REQUEST FOR INFORMATION DATE: September 01, 2016 NO.: RFI-266

Project Name: 15051-Webster University Interdisciplinary Science Building Project No.: 15051

Subject: Conduit Required for Pole Base Ground Cable to ground rod

LIGHTING POLE "EG" CONCRETE BASE DETAIL

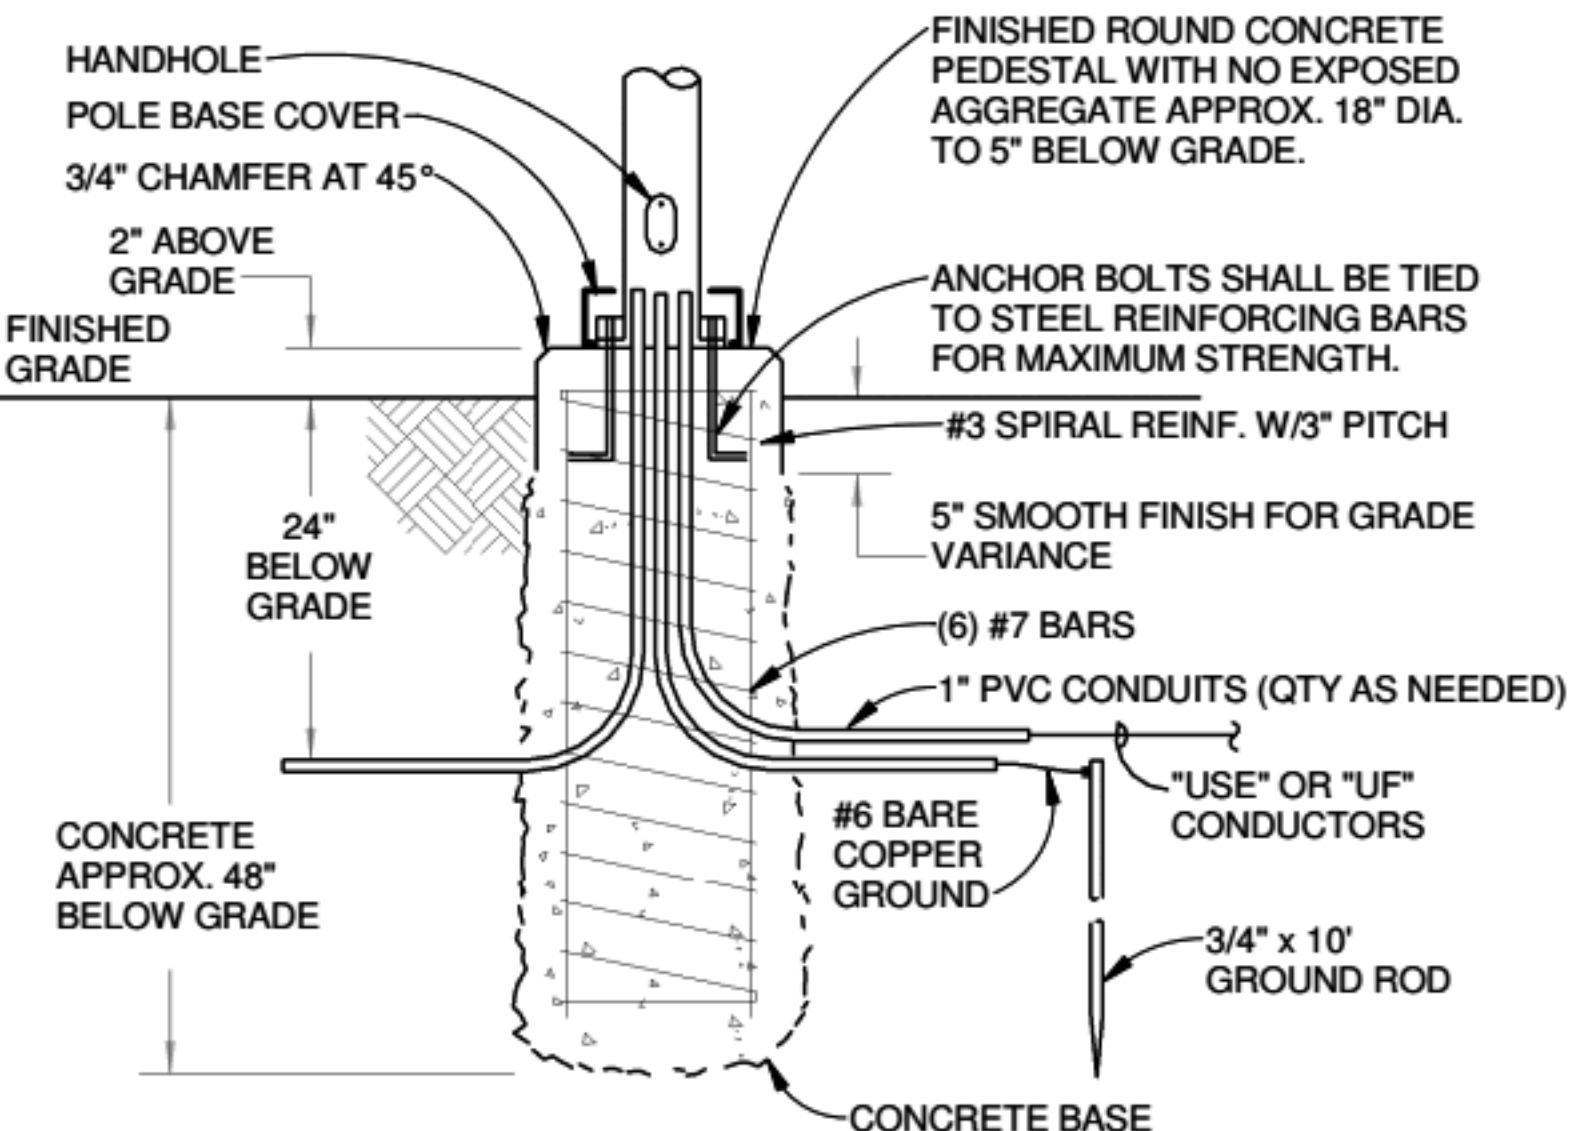
Regarding the amount of conduits entering and exiting the type EG5, EG5R and EG3 pole lights;

1. Can we utilize 3/4" conduit in lieu of 1" conduit to run the sight lighting power and control wiring in.
2. Can we run the # 6 bare ground wire with out a conduit, this would eliminate (1) 1" PVC Conduit and help free up needed room in the pole. See attached.

Provided the code required conduit fill is not exceeded for the current carrying conductors, 3/4" conduit is acceptable where 1" conduit would be too difficult to install.

Regarding the ground conductor, provide a 1/2" PVC conduit in-lieu of the 1" conduit.
